TCEQ Dam Inspection Report

INVENTORY NO.: TX 03288 WATER RIGHT AUTHORIZATION: Adjudication 4560A

DAM: Franklin County Dam

INSPECTION DATE: September 13, 2005 PREVIOUS INSPECTION DATE: May 7, 2002

Photo 1: Utility pole leaning (≈ 11 degrees from vertical) towards downstream slope just above a noted slide

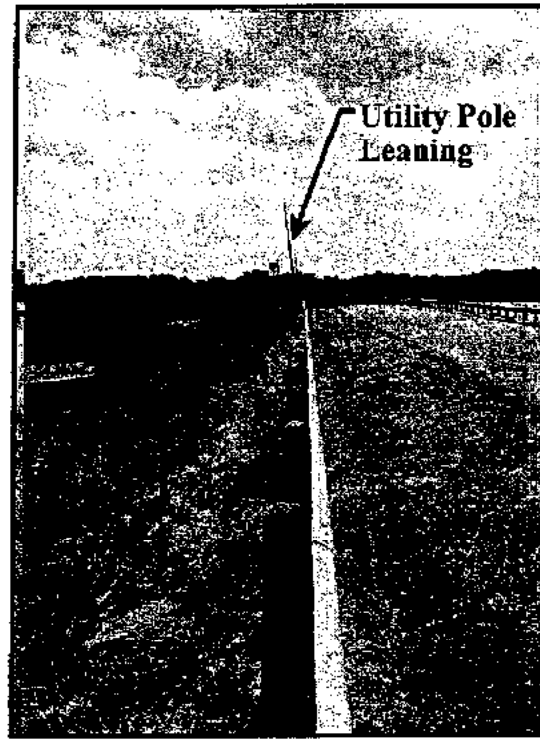
1. The crest of the dam was in good condition. Also serving as a major road (Highway 3007), the 25-foot wide paved crest had a straight alignment, and no significant ruts or depressions were noted along its roughly 5250-foot length. Additionally, the guardrails adjacent to the road along each edge of the crest showed no indication of alignment problems.
2. It should be noted that one of the utility poles that runs along the eastern edge of the crest was severely leaning towards the downstream embankment [Photo 1]. Located near the mid section of the dam's northern half, the slanted utility pole was located just above an area of the downstream slope where a slide had occurred.

4. Near the mid section of the dam's northern half, a slide approximately 10 foot wide by 6 foot deep was noted about midpoint on the slope, just below the previously noted leaning utility pole [Photo 1]. Small slides (some reoccurring slides) were seen across the downstream embankment with a higher concentration near the middle of the dam [Photo 11].

3. The continual deterioration of the downstream embankment should be addressed. With the steep slope that presently exists, the historic problem with slides will persist indefinitely. Many past slides have been fixed, yet many have reoccurred in the same location(s). The application of fly ash/lime mix with geo-fabric has been attempted in the past to combat the slides; however, these efforts have not proven effective. The specific clay material that composes the downstream slope is highly susceptible to cracking from dry conditions, and this allows rain water to penetrate into the dam. This wet, saturated soil then loses its cohesion due to the steep downstream slope and slides. A minimum slope of at least 3H:1V is recommended for the downstream embankment as a long term solution to the slide problems. This work should be undertaken under the supervision of a Registered Texas Professional Engineer (RTPE) with experience in the repair of dams. It is also recommended that a cost analysis be prepared for repeated slope repair versus permanent slope repair as an aid to the dam owner. All plans should be submitted to TCEQ for review and approval before any work starts.

Photo 4: Pocket in rip-rap on upstream slope; it did not appear to be moving

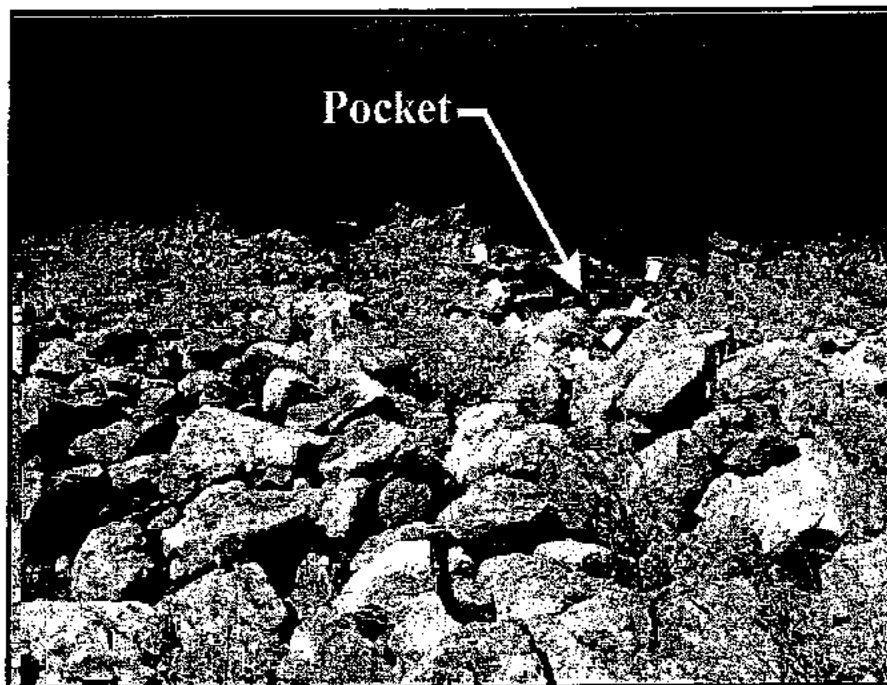
1. The overall condition of the upstream embankment was fair. The slope varied from 3 horizontal to 1 vertical (3H:1V) to 2H:1V across most of the upstream embankment [Photo 2]. It reached almost a 1H:1V slope in some areas near the crest.
2. Large rip-rap protected the entire shoreline, as well as the majority of the upstream slope. Some of the shale rip-rap stones were severely weathered and cracked and would break apart when struck with a survey rod [Photo 3].
3. There was a pocket in the rip-rap at one spot along the shoreline of Lake Cypress Springs;

however, it did not appear to be moving out and away from the crest [Photo 4].

4. The upstream slope rip-rap is intact, yet very weathered in places. Some of the rock is deteriorating and becoming brittle with age, and its effectiveness in a major flood event is questionable. The condition of the rip-rap should be regularly checked as part of the routine maintenance and monitoring plan, and action to replace the deteriorated rip-rap should be considered.

Photo 5: Small trees and brush growing through voids in rip-rap

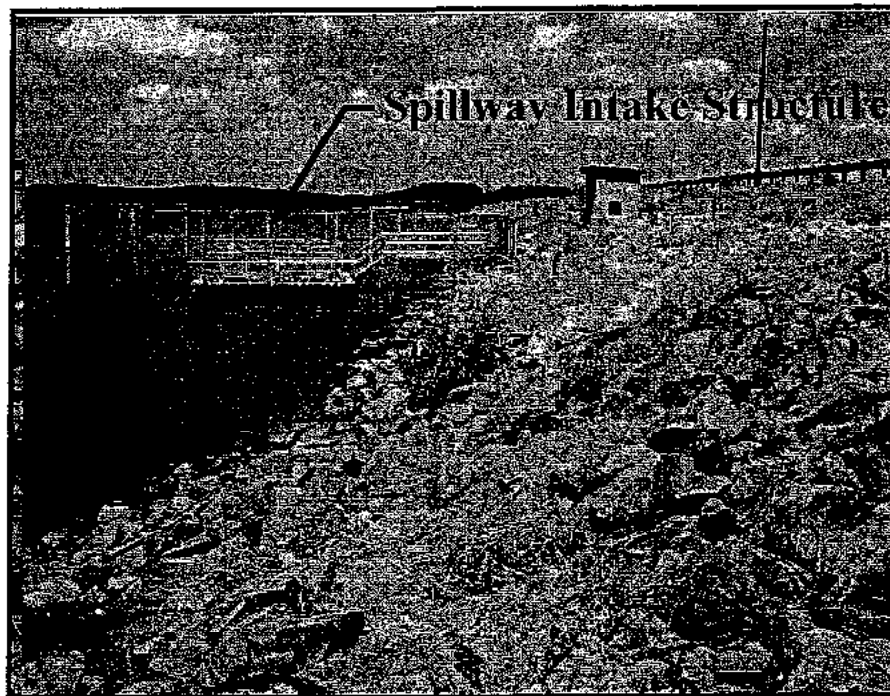
4. Many small trees and brush were growing through the voids in the rip-rap [Photo 5].
5. Numerous small sloughs, holes, and undulations were characteristic of the entire upstream embankment [Photo 6].
6. Additionally, quite a few small rodent burrows were noted [Photo 7].

Photo 8: Prevailing vegetation on downstream slope

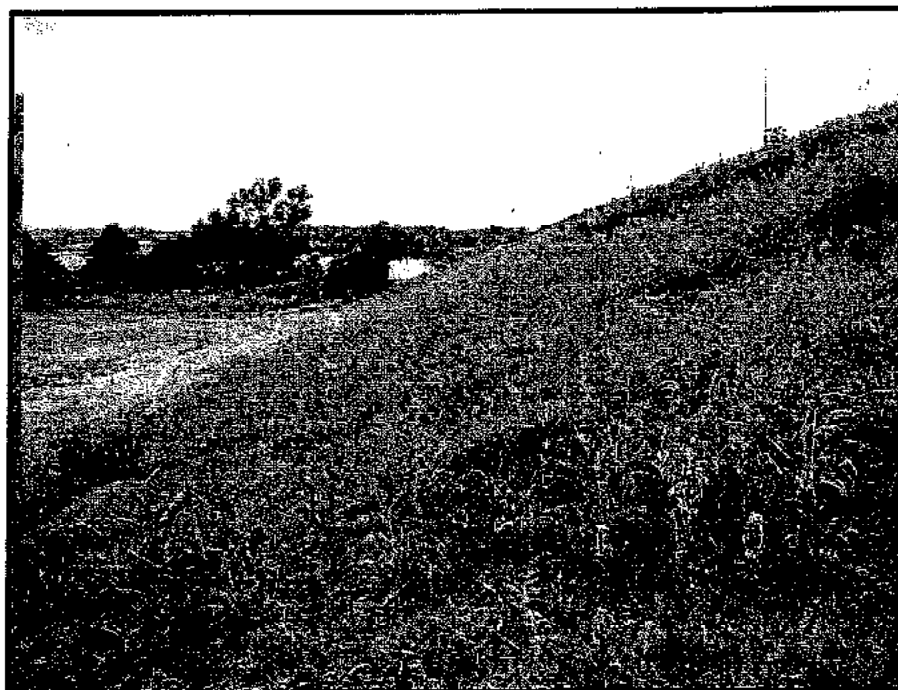
2. Although vegetation seemed to be prevailing over much of the downstream slope [Photo 8], it was bare in some areas. Small trees and brush were observed across most of the downstream embankment; however, a herbicide had obviously been applied in conjunction with an ongoing maintenance plan. The vast majority of this undesired vegetation was either dead or dying off, yet the clearing phase had not been initiated at the time of the inspection.

5. It is recommended that the downstream slope not be mowed any longer, as this action is likely doing more damage than good. Still, tree and shrub growth should be controlled.

Photo 9: Holes and undulations across downstream embankment

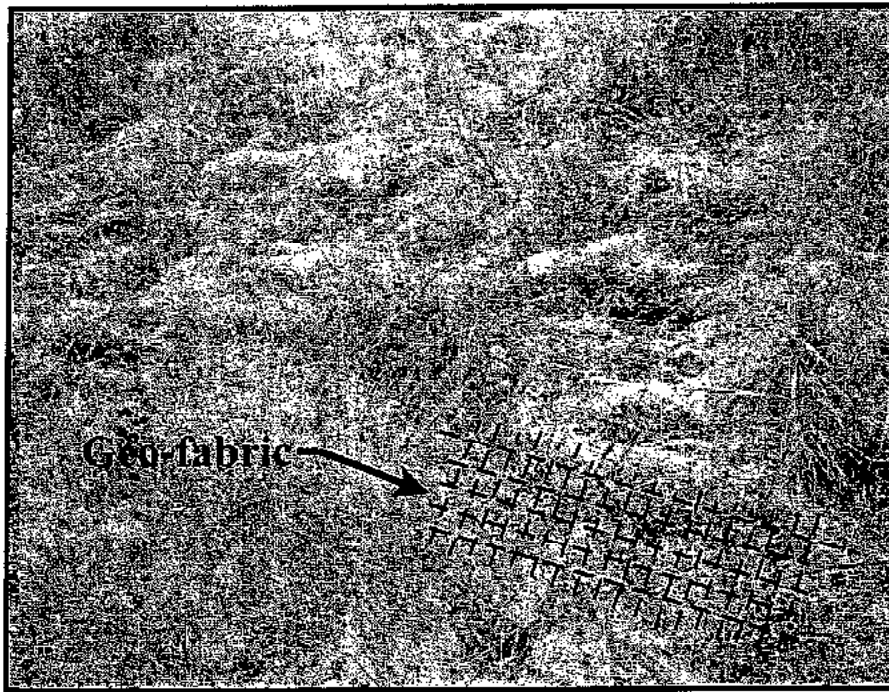
3. Many small sloughs, holes, undulations, and gullies were characteristic of the entire downstream embankment [Photos 9 & 10]. It should be noted that a geo-fabric had been placed on old slide areas on the downstream slope, in an effort to promote vegetative growth and combat the continual erosion.

6. Reshape and repair the areas that have been damaged by animal burrows with well compacted non-dispersive clay material.
7. All of the bare, eroded areas on the downstream embankment should have a vegetative cover reestablished.

Photo 12: Standing marsh at north end of downstream area

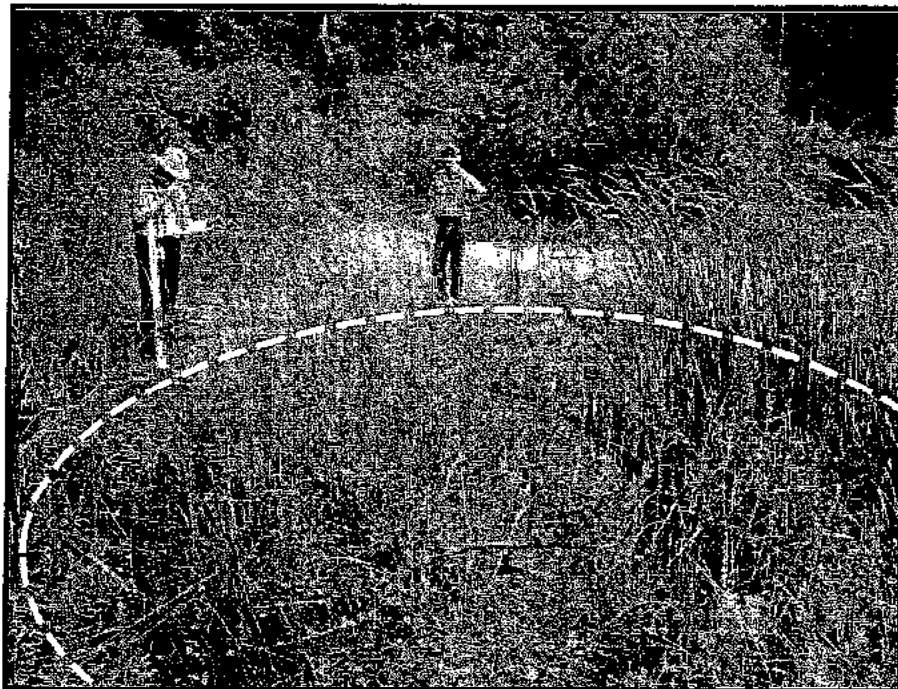
1. In both the left and right downstream groins, near the toe of the dam, minor seepage was noted.
2. At the north end of the downstream area, a standing marsh was witnessed [Photo 12]. It could not be determined if the water was due to seepage, a covered toe drain, or possibly a spring.

1. The District's maintenance and monitoring plan should be continued and should include monitoring of the seepage areas.
2. An official Emergency Action Plan (EAP) is not presently on file with the TCEQ for this dam; however, it is rated significant-hazard. It is strongly recommended that an EAP be prepared and kept current. An EAP should provide a systematic means to: identify emergency conditions threatening a dam; expedite effective response actions to prevent dam failure; and prevent or reduce the loss of life and property damage should dam failure occur. This plan can be a positive step by the dam owner to accomplish safety objectives, protect the investment, and reduce potential liability. The following website gives guidelines for developing an EAP: www.fema.gov/fima/damsafe/eap_toc.shtml. Note that these guidelines were developed for larger dams, nevertheless, they provide a general overview of the EAP's purpose. A proposed EAP should be submitted to the TCEQ Dam Safety Program for

Photo 14: Morning glory service spillway drop inlet; note the minor concrete spalling

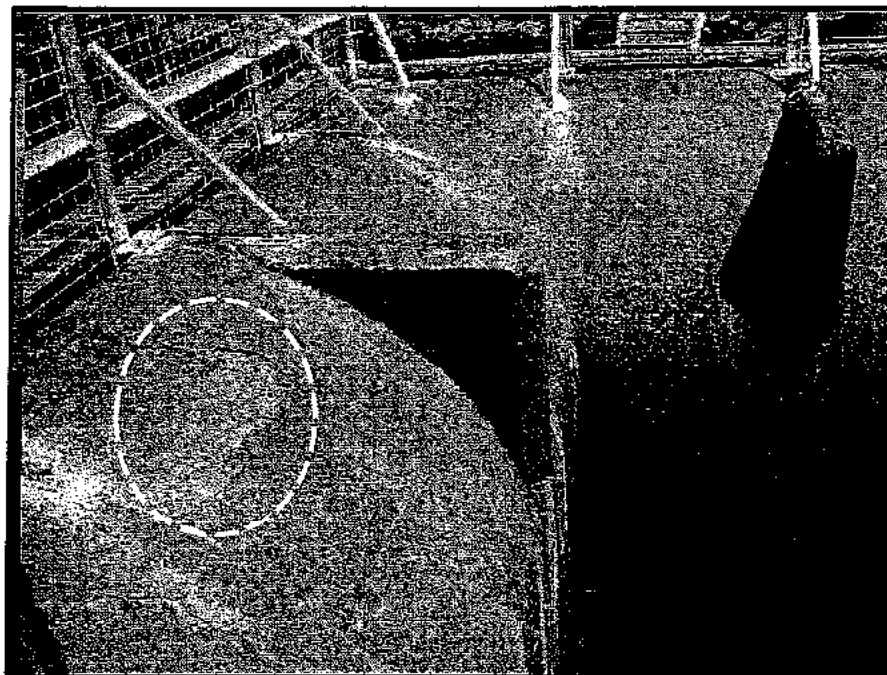
1. The morning glory spillway inlet was in good condition [Photo 14], and only minor spalling of the concrete was detected. Still, Lake Cypress Springs was roughly two feet below the spillway drop inlet elevation, and the operation of the spillway was not witnessed.
2. The service spillway drop inlet, the instrumentation and control room, and the low flow intake valves [Photos 15 & 16] were all well maintained and secure with the necessary fencing, locks, etc.
3. The fish screen was intact and in good condition [Photo 16]. The fish screen and walkway to the morning glory had been painted the day before.
4. The condition of the service spillway outlet could not be assessed, as it was beneath the water level of Lake Bob Sandlin located immediately downstream.

3. The long term effects of the service spillway's surging action should be investigated. The interior of the spillway conduit was first inspected in 1977 for deterioration, and it should be examined again. When it was first inspected, the dam had only been in operation for about six years, and the continual vacuum breaking had already caused a couple of joints in the conduit to begin offsetting roughly an inch. The dam is now 35 years old, and the damaging effects of the routine vacuum breaking/cavitation on the structural integrity of the spillway conduit should be assessed. It is recommended that the interior of the conduit be inspected. A diver and/or video camera could be utilized for this purpose. If it is determined that appreciable damage has been done, a piping condition may exist from water leaking through the conduit joints, and a plan should be initiated to remedy the situation.
